UNITED STATES
NUCLEAR REGULATORY COMMISSION
WASHINGTON, D.C. 20555-0001

SUBJECT: TURKEY POINT UNITS 3 AND 4 - ISSUANCE OF AMENDMENTS REGARDING EXTENDED POWER UPRATE (TAC NOS. ME4907 AND ME4908)

Amendment No. 249
Renewed License No. DPR-31

FIGURE 3.4-2 Turkey Point Units 3 and 4 Reactor Coolant System Heatup Limitations (Heatup Rates of 60 and 100°F/hr) Applicable for 48 EFPY (Without Margins for Instrumentation Errors)

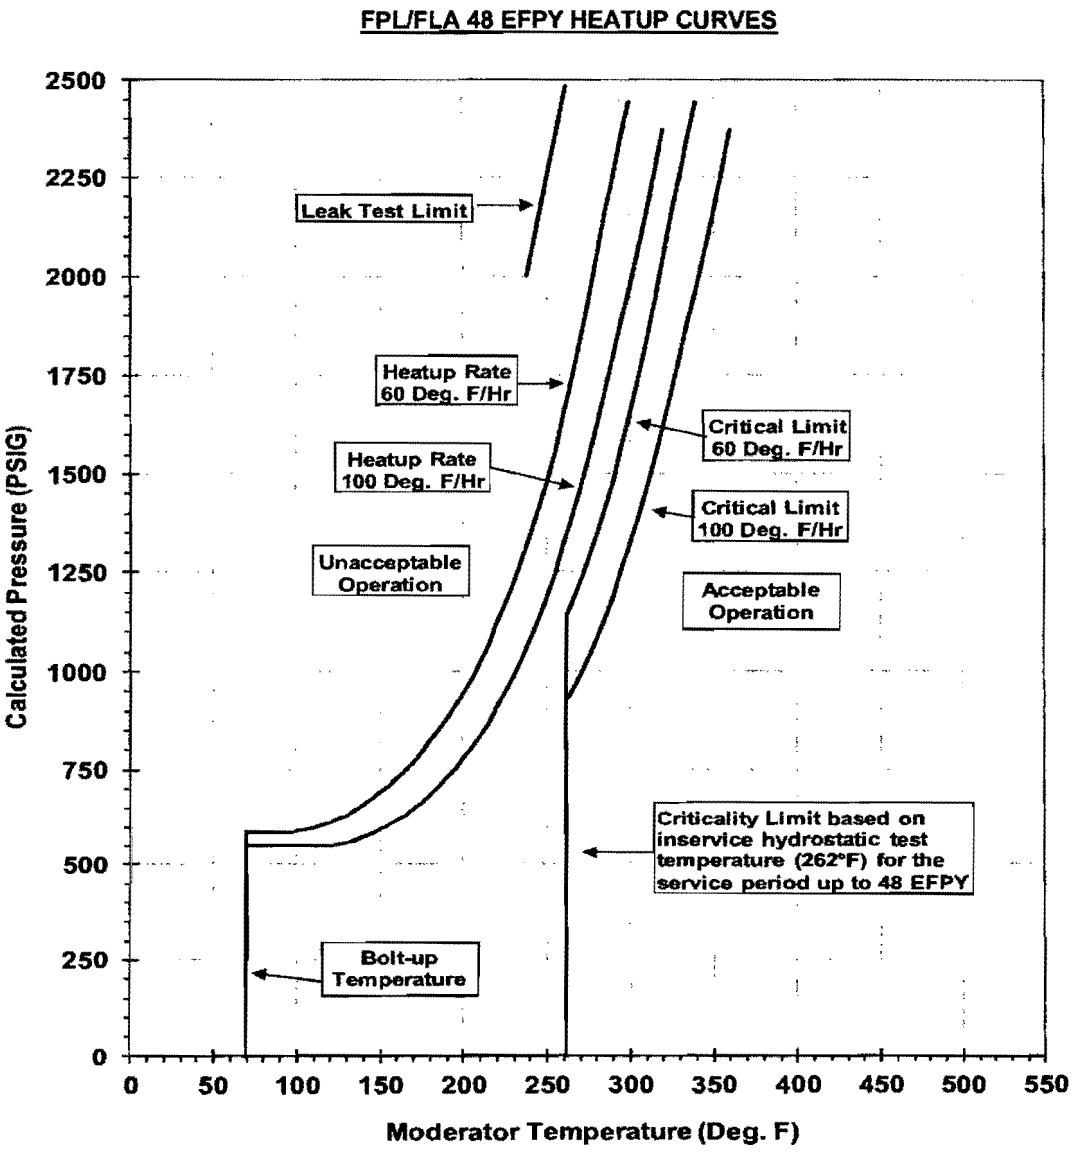
To support the EPU, the licensee prepared new P-T limits valid through 48 EFPY. Revised heatup curves were provided as technical specifications (TS) Figure 3.4.2, and the revised cooldown curves were provided as TS Figure 3.4.3. The same figures were provided as Figure 2.1.2-1 and 2.1.2-2 of the LR. The licensee provided a markup of TS Bases 3/4.4.9, which indicates that the licensee used the methodology of WCAP-14040-NP-A, Revision 2, "Methodology Used to Develop Cold Overpressure Mitigating System Setpoints and RCS [Reactor Coolant System] Heatup and Cooldown Curves."[15] The licensee also referenced "WCAP-15092, Revision 5, "Turkey Point Units 3 and 4 WOG [Westinghouse Owners Group] Reactor Vessel 60-Year Evaluation Minigroup Heatup and Cooldown Limit Curves for Normal Operation," as the basis for the current P-T limits, but did not provide the report with the EPU submittal. In a conference call on January 26, 2011, the licensee clarified that the WCAP-15092, Revision 5 report did not account for EPU, and that the methodology used to

Figure 2.1-1 Reactor Core Safety Limit – Three Loops in Operation (Highest Loop Average Temperature (°F) vs Core Power (fraction of 2644 MWt) is as shown below

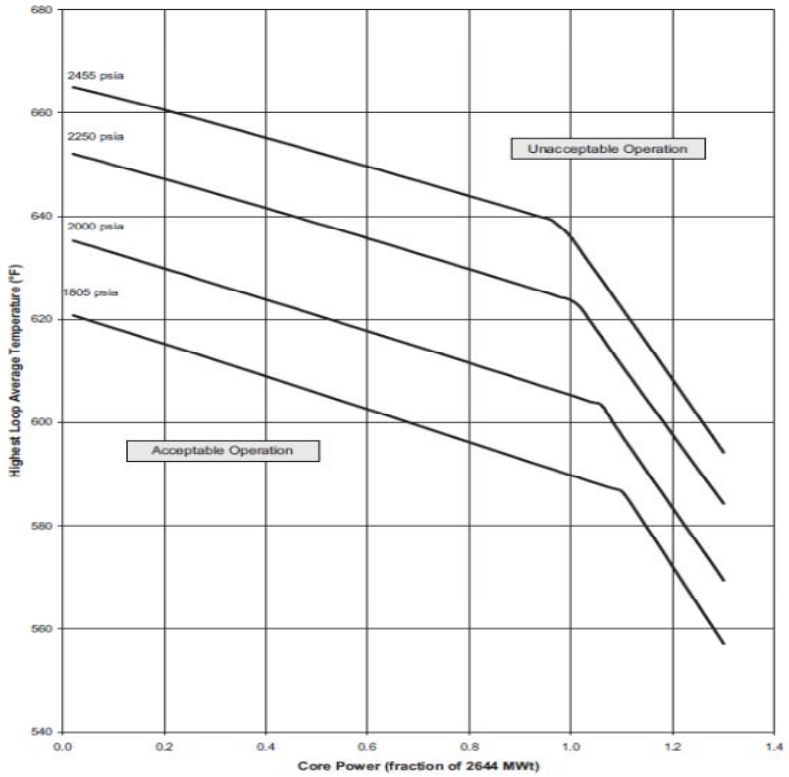
> Departure from Nucleate Boiling (DNB) analyses were required to define new core limits, axial offset limits, and Condition II accident acceptability to support operation at EPU conditions.

By Letter dated March 15, 2012,[169] FPL identified those COLR TS pages issued in Amendment Nos. 247 and 243 that supersede the EPU application TS pages. In addition, the licensee also stated that the EPU parameters included on these pages will be relocated to the COLR and that the values of the relocated parameters remain unchanged from the values reviewed by the NRC staff for the EPU LAR. Each COLR value submitted under the EPU LAR but which are relocated to the COLR as a result of the February 24, 2012, approval are described and evaluated in this safety evaluation. Figure 2.1-1 has been relocated to the COLR.

Figure 3.1-1, "Required Shutdown Margin vs Reactor Coolant Boron Concentration," is revised as shown in the figures below to provide a separate curve representing the minimum allowable shutdown margin in Mode 4 when no reactor coolant pumps are operating.

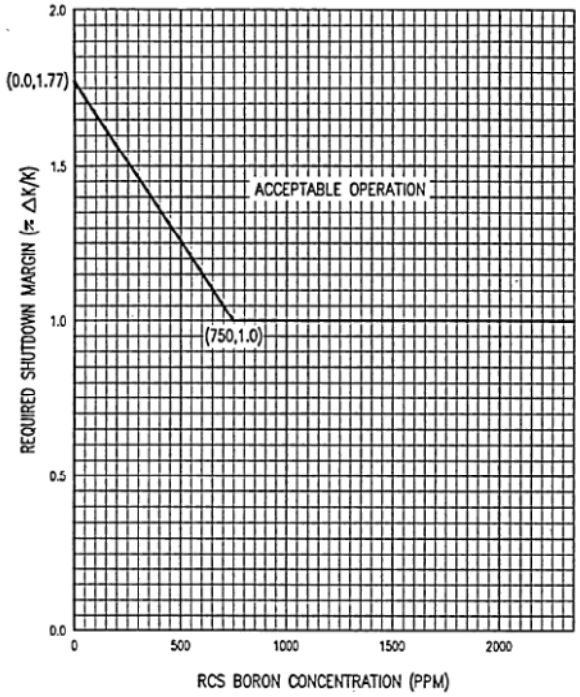
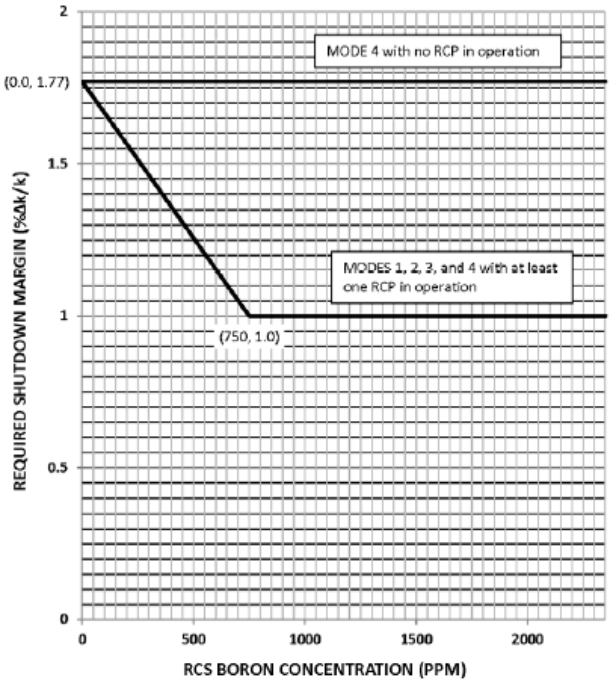
3.1.1.1 The SHUTDOWN MARGIN shall be greater than or equal to the applicable value shown in Figure 3.1-1.

By Letter dated March 15, 2012, FPL identified those COLR TS pages issued in Amendment Nos. 247 and 243 that supersede the EPU application TS pages. In addition, the licensee also stated that the EPU parameters included on these pages will be relocated to the COLR and that the values of the relocated parameters remain unchanged from the values reviewed by the NRC staff for the EPU LAR. Each COLR value submitted under the EPU LAR but which are relocated to the COLR as a result of the February 24, 2012, approval are described and evaluated in this safety evaluation. This figure has been relocated to the COLR.

Figure 3.1-2 Boric Acid Tank Minimum Volume (1) – Modes 1, 2, 3, and 4 (Minimum BAT Volume vs BAT Inventory Concentration) is revised as shown below

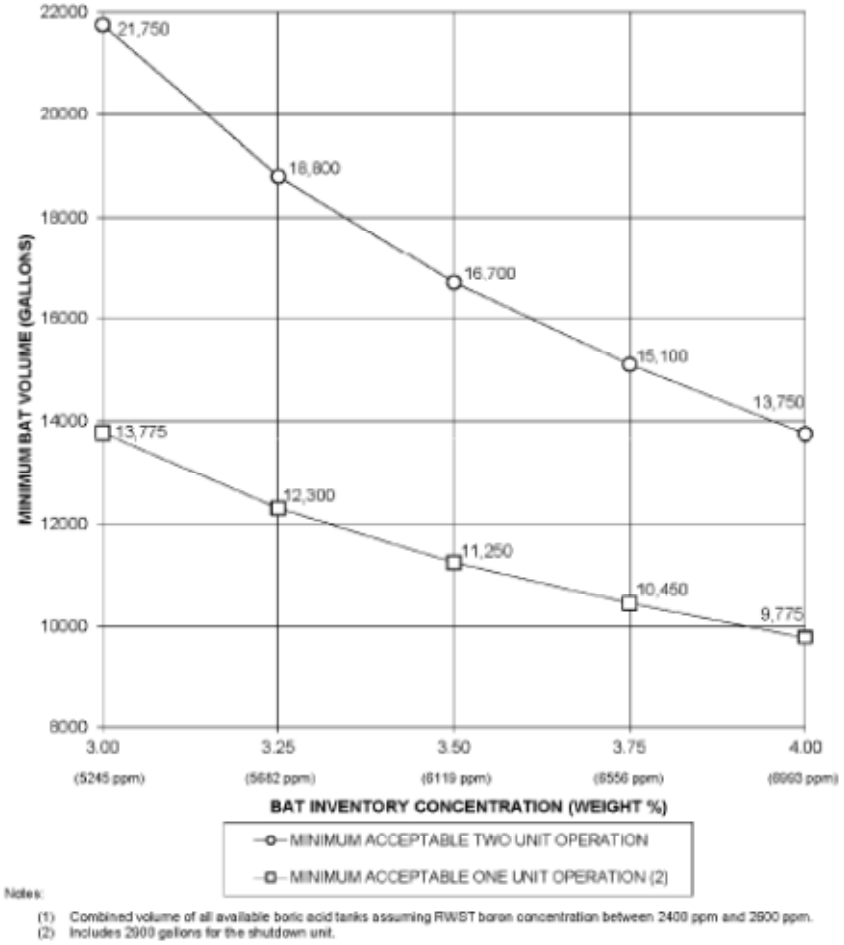
In a supplement dated January 10, 2012 the licensee provided the above Figure 3.1-2 that included tank level instrument uncertainty and the following basis for the change.

> The Boric Acid Tank Minimum Volume curve (submitted October 21, 2010) did not include tank level instrument uncertainty and is being revised to assure indicated level remained conservative. The total volumetric uncertainty including level measurement and minimum vortex volume has been determined to be limited to 600 gallons so that the minimum volume curves in Figure 3.1-2 have been revised to add 600 gallons for one unit operation and 1200 gallons for two unit operation.
>
> NRC Technical Evaluation
